Docket Number:	12-AFC-03
Project Title:	Redondo Beach Energy Project
TN #:	204742-2
Document Title:	City of Redondo Beach - Preliminary Staff Assessment Workshop - Alternatives
Description:	Presentation By Jon Welner
Filer:	Jon Welner
Organization:	Jeffer Mangels Butler & Mitchell LLP
Submitter Role:	Intervenor Representative
Submission Date:	5/26/2015 6:33:30 PM
Docketed Date:	5/27/2015

Redondo Beach Energy Project
Preliminary Staff Assessment Workshop
Alternatives

Presented by Jon Welner

May 21, 2015

*Figure III-2
Western LA Basin A-Bank Substations*

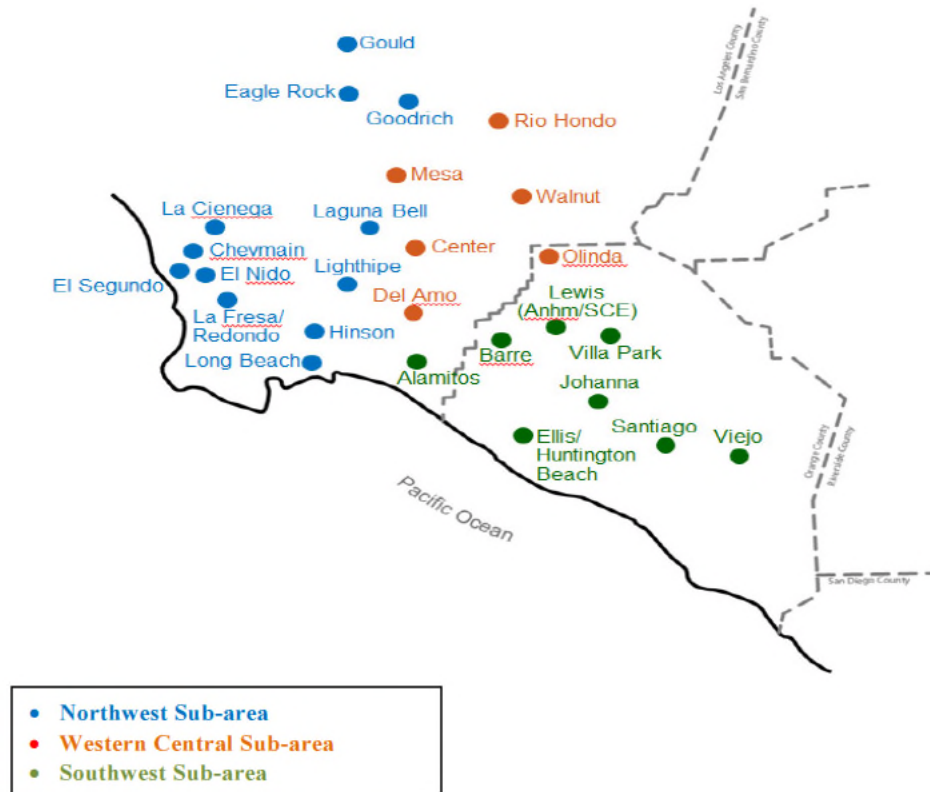
**GAS-FIRED PLANTS ARE ONLY NEEDED IN THE SOUTHWEST SUB-AREA
(REDONDO IS IN THE NORTHWEST SUB-AREA)**
